SERVICE INSTRUCTION

INSTALLATION OF ROTARY WATER PUMP SEAL / PUMP IMPELLER

SI-912-001

SI-914-001

Bild / Fig. 1

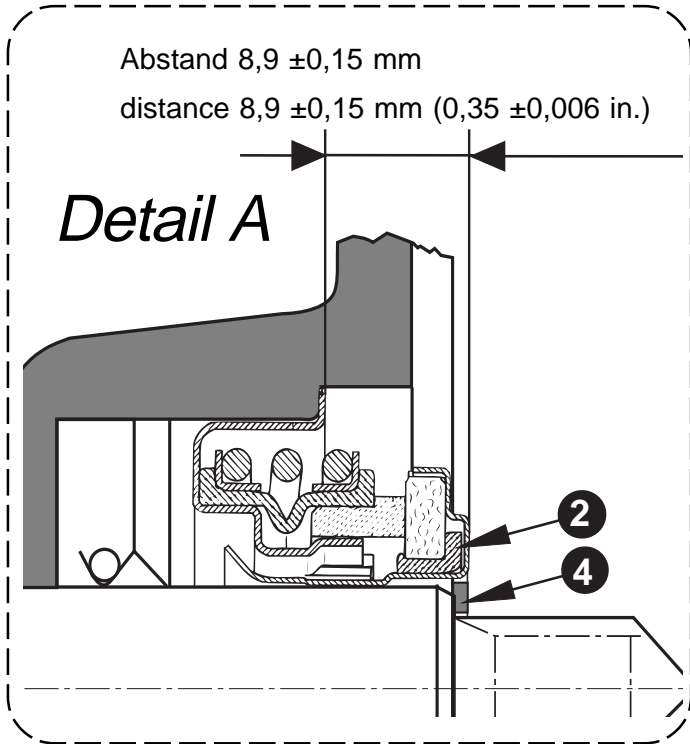
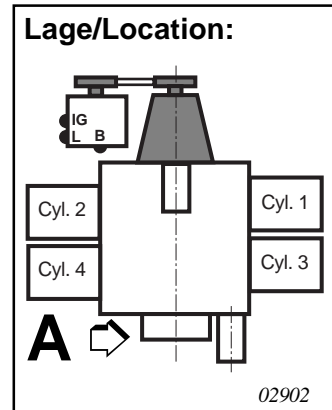
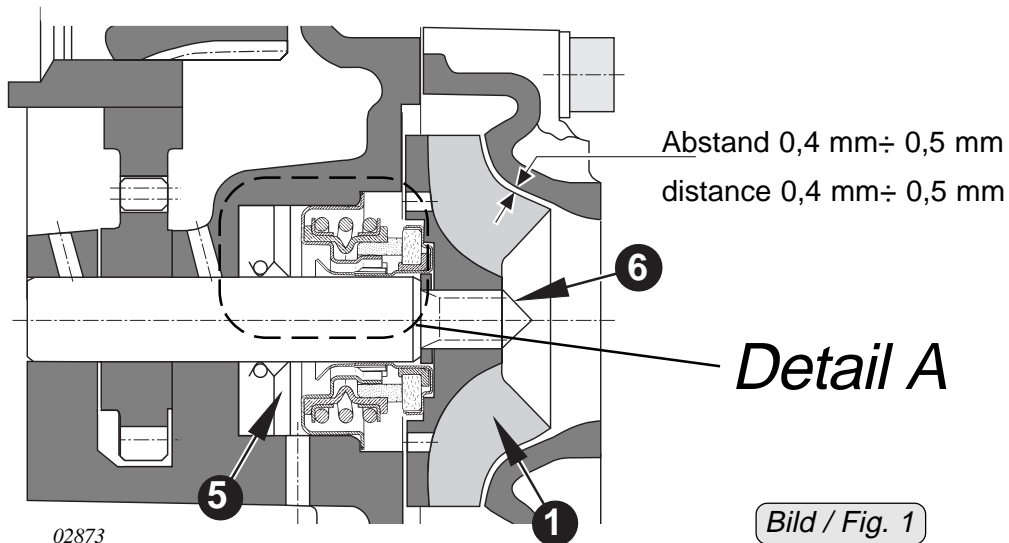
- The oil seal ⑤ must be replaced as per the instructions found in the current relevant Maintenance Manual and/or Repair Manual (ICR-Manual).
- The **new rotary seal (part no. 850.945) ②** and the **new washer (part no. 926.273) ④** must be installed as per the instructions found in the current relevant Maintenance Manual and/or Repair Manual (ICR-Manual). The **new rotary seal insertion punch (part no. 877.259) ③** must be used. Very careful handling and installation of the rotary seal is vital in preventing coolant loss.

- Ensure that water pump shaft is parallel to seal bore during installation.
- If the shaft is not parallel to the bore when installed, the edge of the shaft can dimple the soft material of the seal bore, reducing the sealing effectiveness of the press fit. To increase the effectiveness of the press fit **between the pump shaft ⑥ and the seal, a small amount of LOCTITE 243 adhesive** must be applied around the shaft.

- If **distance (shown in fig. 1) is not within 8,9 ±0,15 mm (0,35 ±0,006 in.)**, the seal spring has been over-compressed and the seal must be replaced.

- Impeller of new design (part no. 922.224) **①** must be installed with new rotary seal. Installation as per instructions in the current relevant Maintenance Manual and/or Repair Manual (ICR-Manual).
- The **distance** (shown in fig. 1) **between 0,4 mm ÷ 0,5 mm (0,016 in. ÷ 0,02 in.)** must be verified in accordance with the current, relevant Maintenance Manual and/or Repair Manual (ICR-Manual). If measurement is not within manufacturers recommendations the installation procedure wasn't followed properly and the rotary seal and oil seal is no longer serviceable. The seals must be removed and a new rotary seal and a new oil seal must be installed as per manufacturers recommendations.
- Reconnect the aircraft battery.

Bild 2/ fig. 2 02722

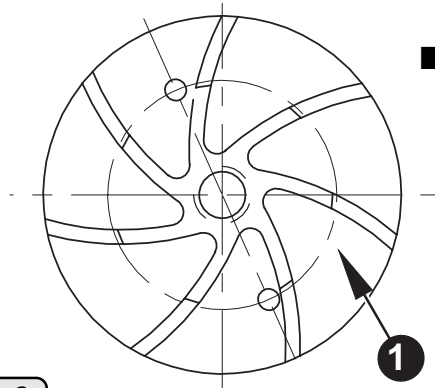
The illustration below shows the new impeller with 2 holes:

■ **ATTENTION:**The impeller can only be utilized for the new rotary seal (part no. 850.945).

Bild 3/ fig. 3 03222

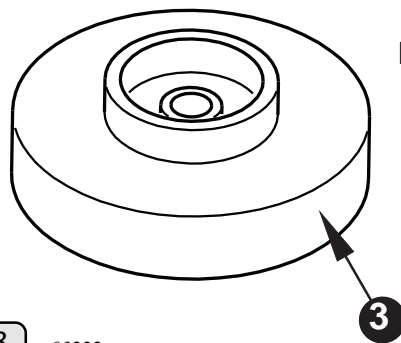
The illustration below shows the new insertion punch:

■ **ATTENTION:**The new insertion punch can only be utilized for the new rotary seal (part no. 850.945).

Bild 4/ fig. 4 03502

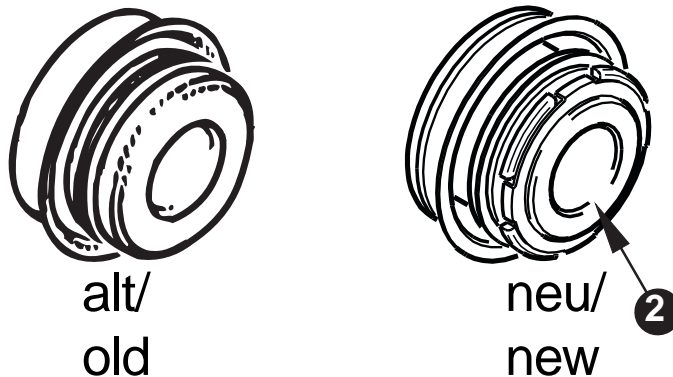
The illustration below show the rotary seal of the old and new design:
